TECHNICAL SERVICE BULLETIN

NO. 182-001

SUBJECT: GUIDE BAR INSERT KIT #A-96612

AFFECTS: 360 CHAIN SAW

INSTALLATION OF GUIDE BAR INSERT FOR 360 CHAIN SAWS

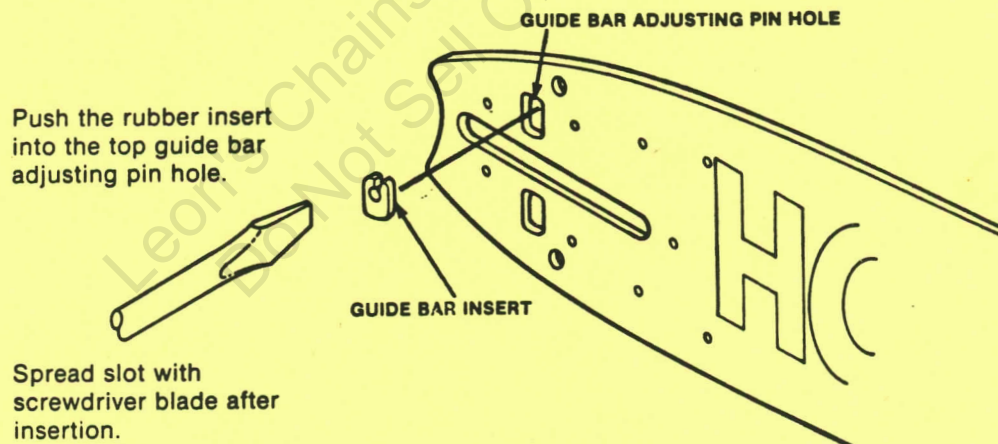
We have had reports from the field that when guide bars longer than 16 inches are used on 360's a minimal amount of oil is getting to the chain. In order to improve the oil flow to the chain a rubber insert for the chain adjusting pin hole of the guide bar has been designed. (See illustration). This insert will route the oil from the oil slot in the guide bar pad directly to the groove of the guide bar.

This insert will be in the new 360 owners kit. If extra inserts are needed order part number A-96612. This kit will contain 5 inserts and 1 instruction sheet.

INCORRECT

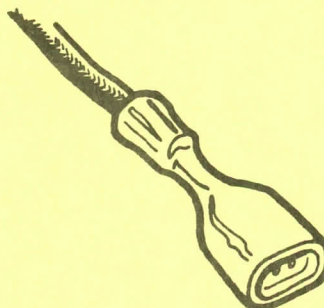
2. Some switch leads, part number A-96378 may have the wrong style connector. Compare your stock to the picture below. The correct connector is colored red and the incorrect is pink. **DO NOT** use the pink ones for service. They will break after a short time.

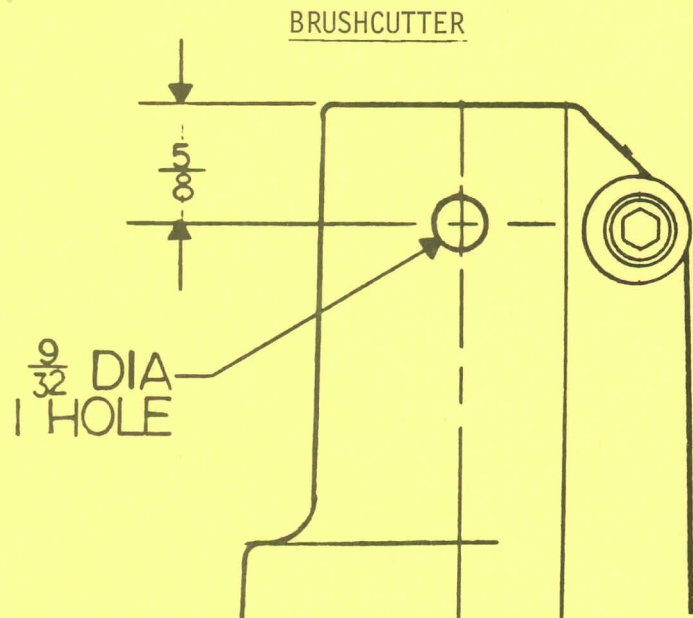
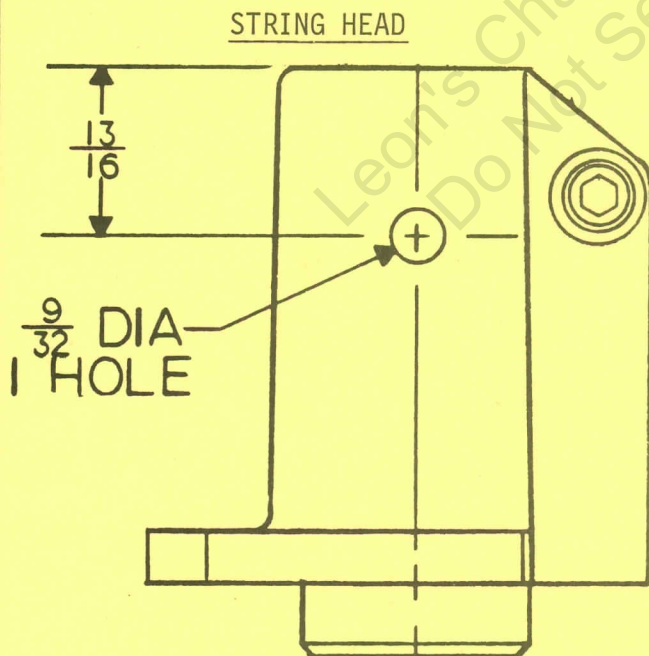
Before the 1982 season all ST-200's were built with the locating hole for the brushcutter or string head in front of the tube. Some tubes of this type broke just above the brushcutter or string head. In order to correct this in the 1982 season, the locating hole was moved from the front to the side and raised closer to the top of the brushcutter or string head housing.

All units built in 1982 have the hole on the side of the tube. A problem arises when a new 1982 ST-200 (hole in side of tube) is matched with an old brushcutter (hole in front of housing). In order to solve this problem use the templates below to drill a new locating hole in the side. Use a $9/32$ " (.2812) drill bit.

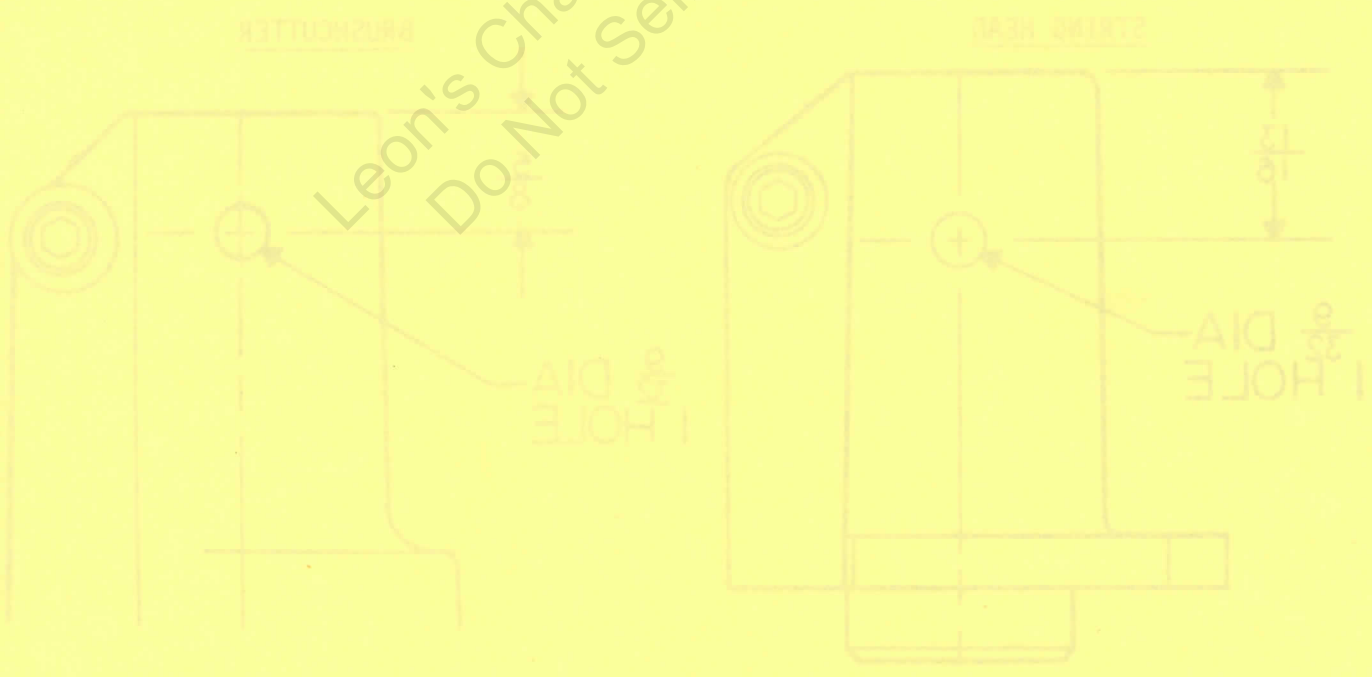
CAUTION: DRILL THROUGH ONE WALL ONLY BEING CAREFUL NOT TO HIT THE SHAFT. ALSO COVER THE EXPOSED BALL BEARING WITH PAPER TO PREVENT METAL SHAVINGS FROM ENTERING IT.

You may also find that when a new tube (hole in side) from service parts is put on an older ST-200, you must drill the existing string head and/or brushcutter.

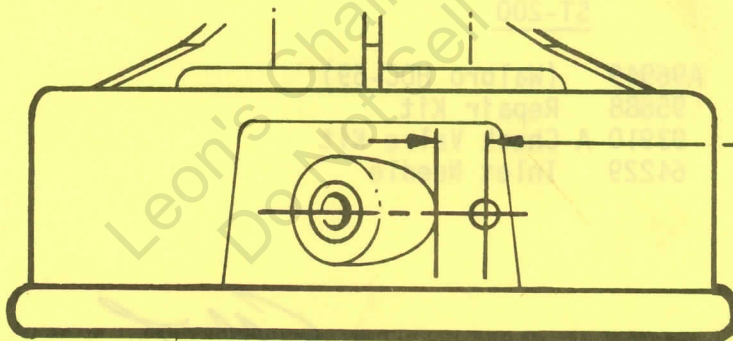
1. As stated in a previous bulletin, the Weldnot tubes are now retained to the stringhead with a cotter pin. A hole is drilled through the stringhead near the string eyelet. The pin is then inserted into the hole and spread apart. This keeps the Weldnot tube from "pounding" the eyelet.

Old stringheads can be updated to accept the new Weldnot tubes. A hole must be drilled near the eyelet for the cotter pin. Refer to the drawing below for the location of this hole. The hole diameter is $1/8"$ ($.125$). The distance from the eyelet to the center of the hole is $1/4"$ to $3/8"$.

OLD - ANGLES FORWARD

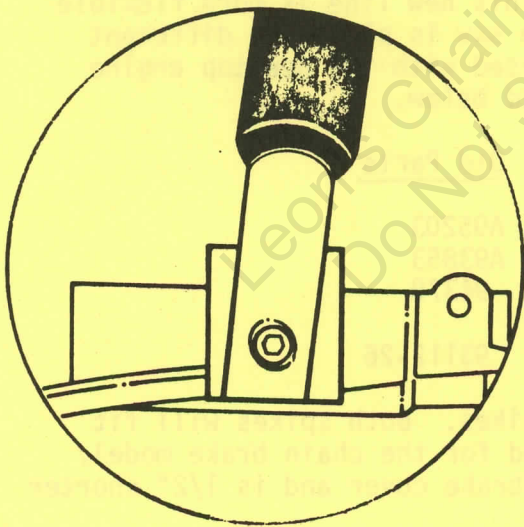
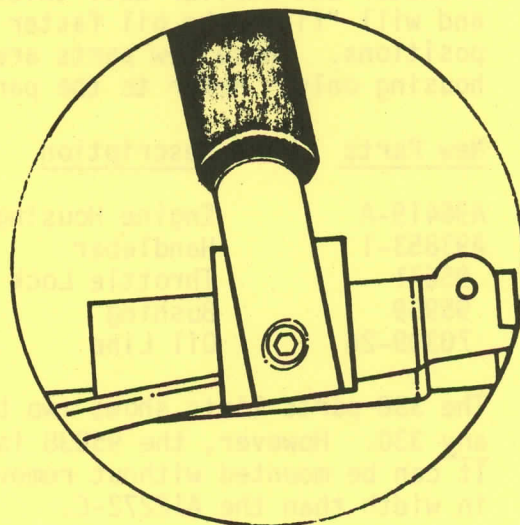
2. The 330 parts lists shows two bumper spikes. Both spikes will fit any 330. However, the 95838 is designed for the chain brake model. It can be mounted without removing the brake cover and is 1/2" shorter in width than the A12272-C.

Currently kit A12272-C contains a spike and two 10-24 x 3/8 screws (88048). In order to use this spike on later 330 models you must also obtain one 10-24 x 3/4 screw (88051) to substitute for one of the 88048 screws. Soon kit A12272-C will be superseded by A12272-D and will contain two 88048 screws and one 88051. The "-D" kit will fit both the 330 and 360.

Illustration #2

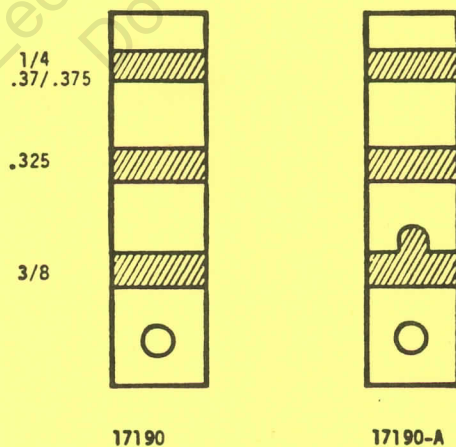
Also, in order to "break" this chain for repair, it will be necessary to use the new 17190-A anvil. (See illustration #2.)

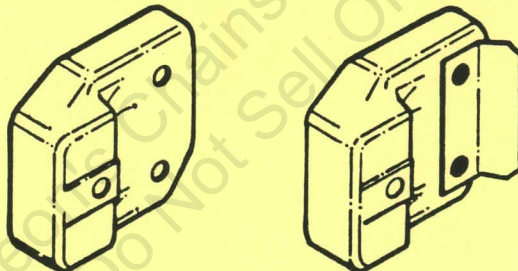
1. This spring we have experienced a number of complaints regarding the SEZ-A0 and vapor lock. The only difference between these units and other SEZ-A0 saws is the addition of the West Coast muffler.

The muffler cap on the West Coast muffler directs the exhaust toward the drivecase cover. As a result the saw will run hotter because the excess heat from the cover transfers through the unit. You may also see discolored air filters and carburetors due to the direction of the exhaust. Heat from these sources contributes to vapor lock.

A deflector has been added to the existing muffler cap to guide the exhaust away from the drivecase cover. See illustration below.

OLD DESIGN

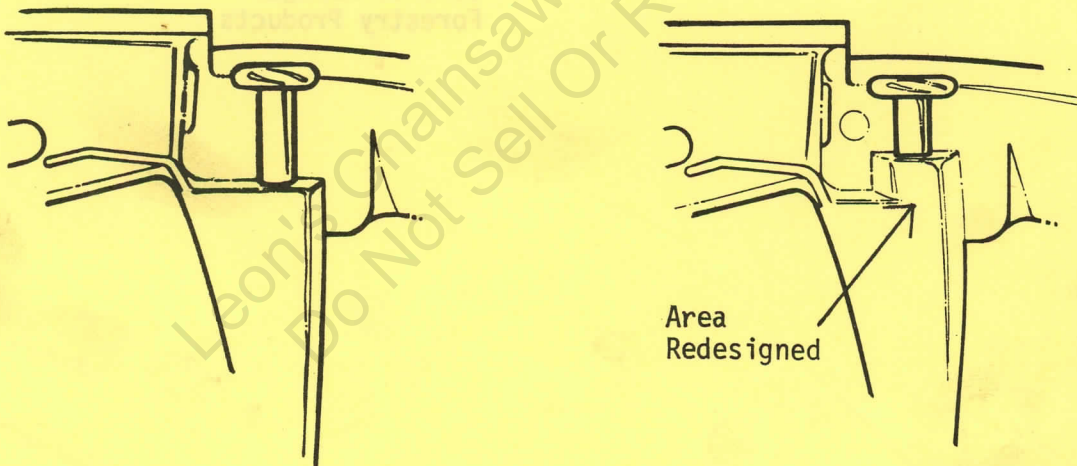
1. The throttle handle has been redesigned to lengthen the bore for the manual oil pump plunger (see illustration). This was done to minimize the "side to side" movement experienced by the plunger when the user depresses the button. The part number did not change. The current number is A93926. This change is effective with the serial number 0D2250000 and above.

A96418A

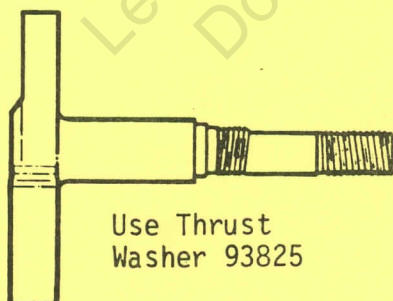
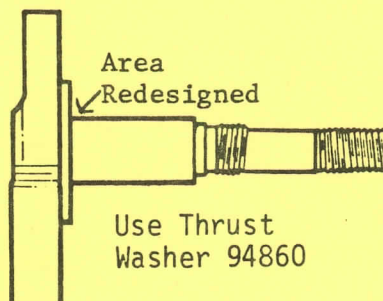
1. To improve unit performance and durability a new piston design A95882-A is available for all 330 chain saws. This new piston incorporates narrow piston rings number 96510. When "thick ring" pistons A95882 are no longer available the part number will be superseded by A95882-A. Note that the "thick" piston rings 93823 are still available.
2. Also, the crankshaft was redesigned in the thrust washer area to increase crankshaft durability. This change required a redesign of the thrust washers. The new washers are part number 94860. Old thrust washers 93825 are still available for servicing crankshafts made before this change. All new crankshafts A96418-B will include thrust washers. See picture below.

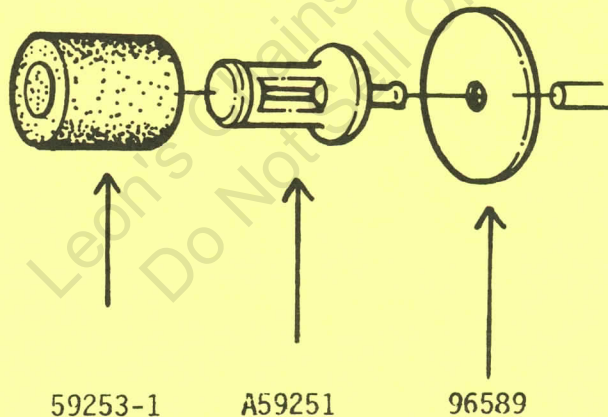
1. The fuel cap material has been changed to prevent deterioration that may occur when gasohol is used. Also, an extra thread was added for better sealing. The new part number is A93420-A.
2. A new rim sprocket 95058 is available from Service Parts. This new rim will supersede sprocket 63284. Both sprockets are 3/8 inch pitch and have seven drive link slots.
3. Plastic washer 96589 has been added to the fuel filter to keep the filter from "hanging up" inside the fuel tank. See picture below.

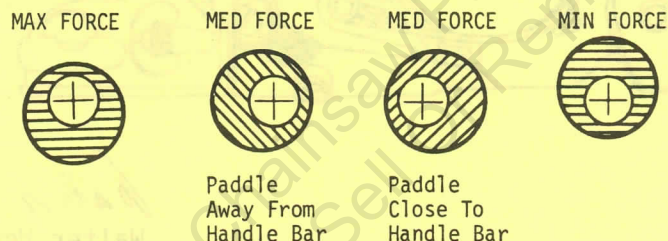
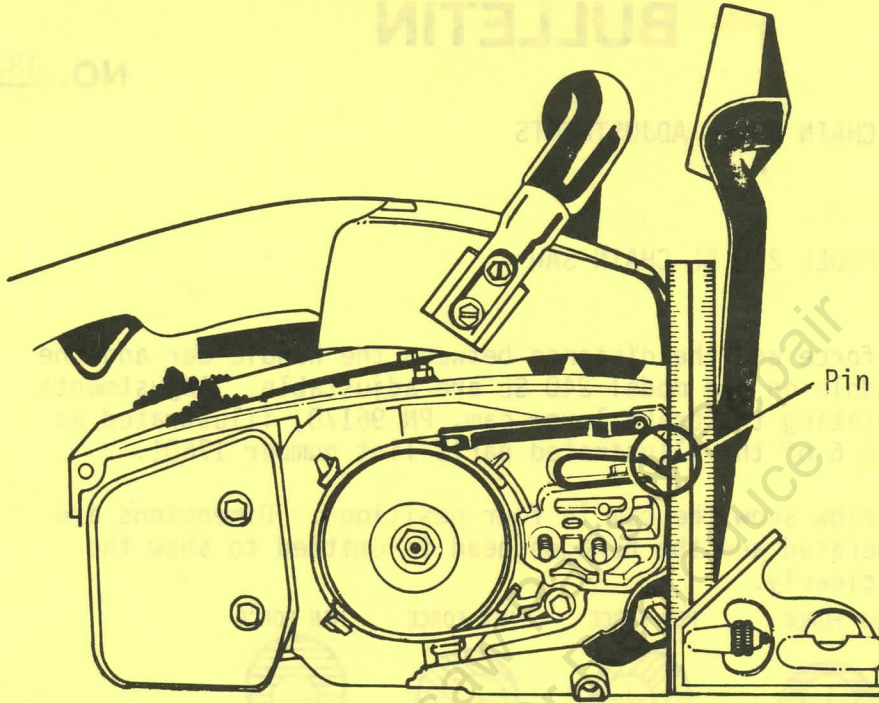
The actuating force and the distance between the handle bar and the chain brake paddle on the model 240 SL are adjustable. Adjustments are made by rotating the brake lever cam, PN 96170, illustrated as item 12 on page 6 of the illustrated parts list number 17601.

The sketches below show the cam in four positions. Dimensions are somewhat exaggerated and the hexagon head is omitted to show the cam positions clearly.

At MAX FORCE and at MIN FORCE adjustments, the paddle to handle distance is identical and intermediate.

As shown by the two center sketches, intermediate actuating forces may be selected with the paddle moving away from, or toward the handle bar.

To change paddle location, or to change actuating force, study the sketches and rotate the cam accordingly.

Force adjustment range is approximately $1\frac{1}{2}$ pounds (0,7 kg). Distance adjustment range is approximately .22 inch (5,5 mm).

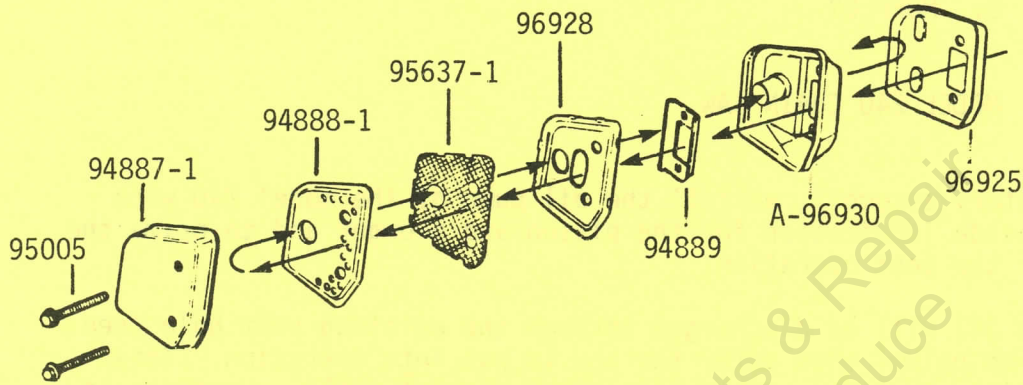
2. A new muffler is used on all 240 chain saws above serial number XD200XXXX. The exhaust is now directed to the rear of the muffler and exits near the cylinder.

NOTE: The muffler cap does not have holes for the exhaust to escape through.

Arrows indicate direction of exhaust flow.

FIGURE "A"

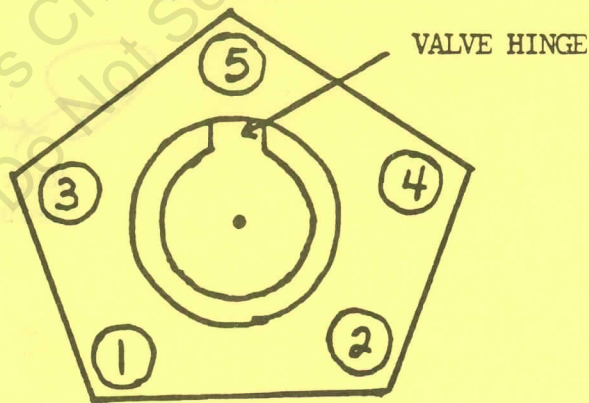
1. Coat both the faces of the pump body and the discharge fitting with a lubricant. Dow Corning number 4 compound, Homelite number 22636-B is used in the factory, and has been found to be the most effective.
2. Snug up the bolts in sequence shown in figure "A" but do not torque at this point.

3. Strike the bottom of the valve body several times in an upward direction with a soft mallet, as shown in figure "B". This properly positions the valve on the valve body. Inspect the valve with a flashlight to assure the valve hinge is completely flat against the valve body. This is easily determined by pushing on the hinged area with a screwdriver. If the valve is not flat you will detect movement of the valve.

FIGURE "B"

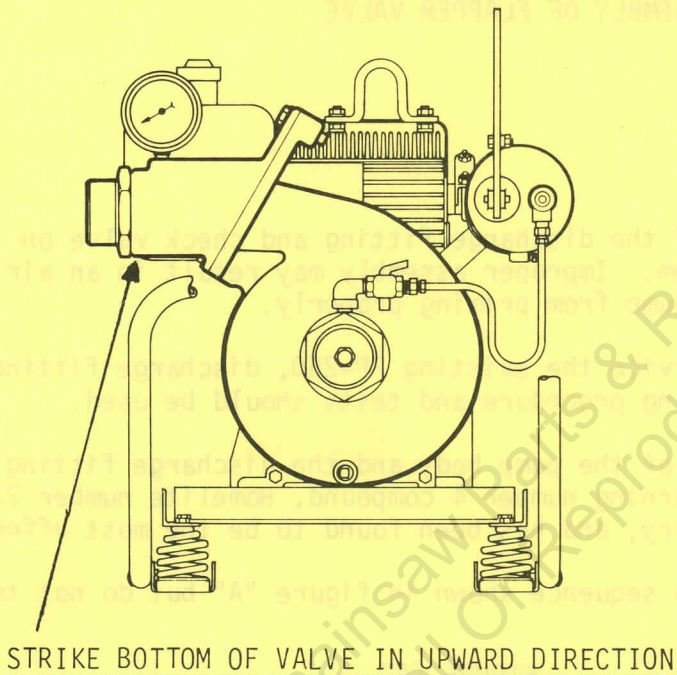
4. Torque all bolts to 240 inch pounds in the sequence shown in figure "A". Check the rubber valve again as described in step number 3. If valve is not flat, repeat procedure.
5. Test pump by measuring maximum vacuum which should be approximately 22 inches of mercury. If maximum vacuum cannot be obtained and the valve is seated properly then the check valve is not the problem.

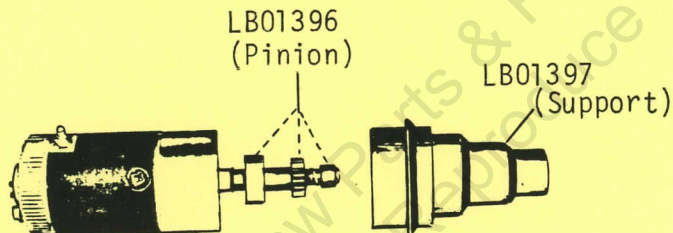
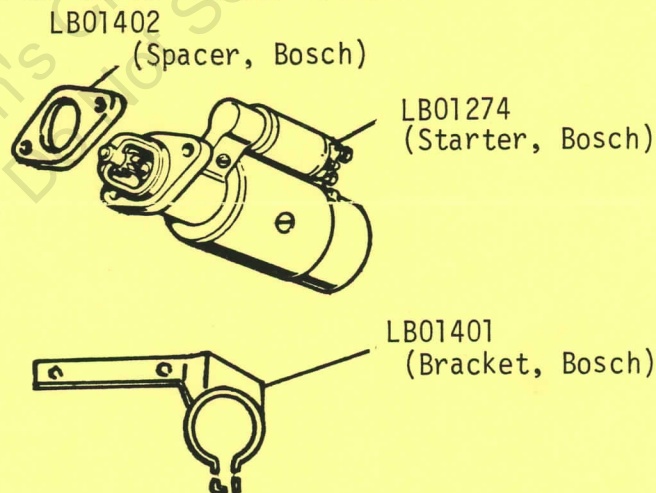
The support (LB-01397) and pinion (LB-01396) for the Prestolite starting motors are now available through service parts. This starter was used on the DTP3-1 prior to serial number 1794629.

The Bosch starters have a spacer (LB-01402) and a different bracket (LB-01401) that are used on all 177D38-1. These parts are also used on all DTP3-1 pumps after serial number 1794629.

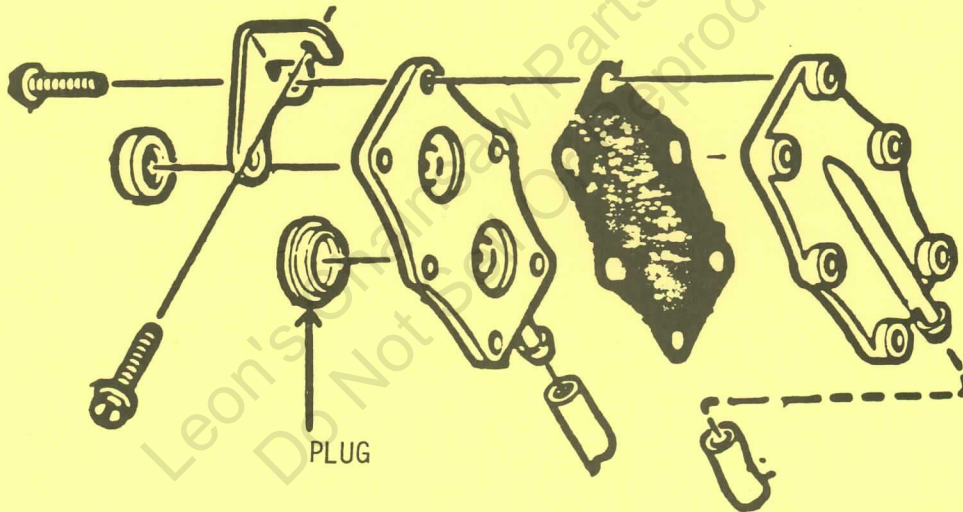
The plug (part number 95789) on the air pump (HB-680) can pop out after a few hours of operation. If this happens there will be a loss of pressure in the fluid tank and the sprayer will not work. The plug must be installed back in place making sure that an adhesive is applied evenly around the outer diameter of the plug (we recommend Zip Grip adhesive, part #70627).

The diffuser vane on the sprayer nozzle of the HB-680 is not made to spin. It should be stationary to give you the swirling wide angle pattern from 5 to 10 feet. The engine speed on all blowers (HB-280, HB-480 and HB-680) is important for proper performance. Idle speed should be set as close to 3500 R.P.M. as possible - not under 3350 R.P.M. nor over 3500 R.P.M. Wide open throttle should be set between 6800 R.P.M. and 7400 R.P.M. for best performance.

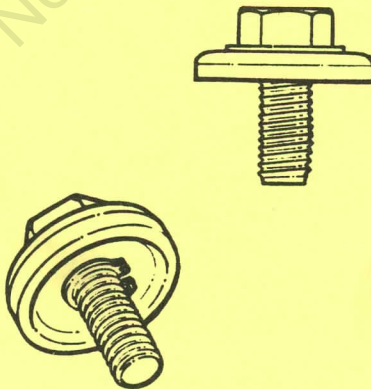
A new bolt and compression washer kit have been released for the above units. This new assembly will increase the holding capability of the cutting wheels and will eliminate any slippage problems that you may be experiencing. Any units that are brought in to you for repair should have this bolt and washer assembly installed before it is returned to the customer.

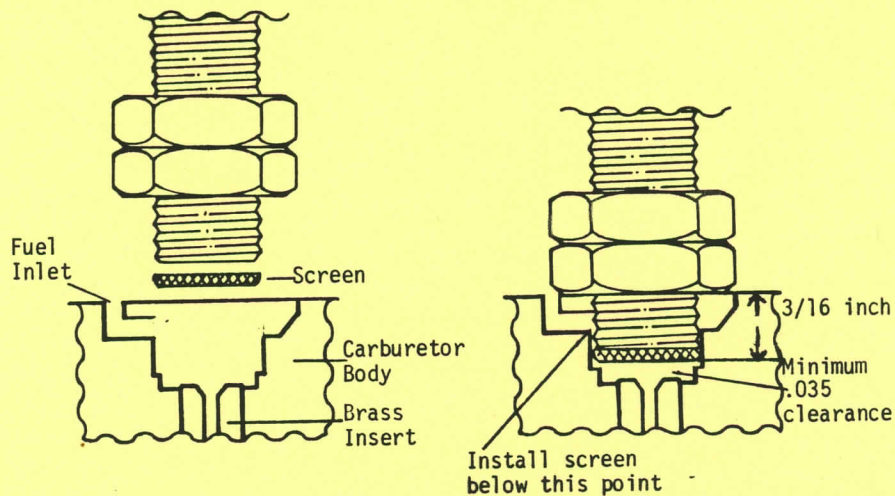
Do not press the screen too deep in the carburetor during installation. A 5/16 - 24 bolt with two nuts is a simple and available tool to install the screen properly.

Use the two nuts to maintain the 3/16 inch depth. This allows the screen to be set in place without blocking the fuel inlet hole, or touching the brass insert pressed into the carburetor body.
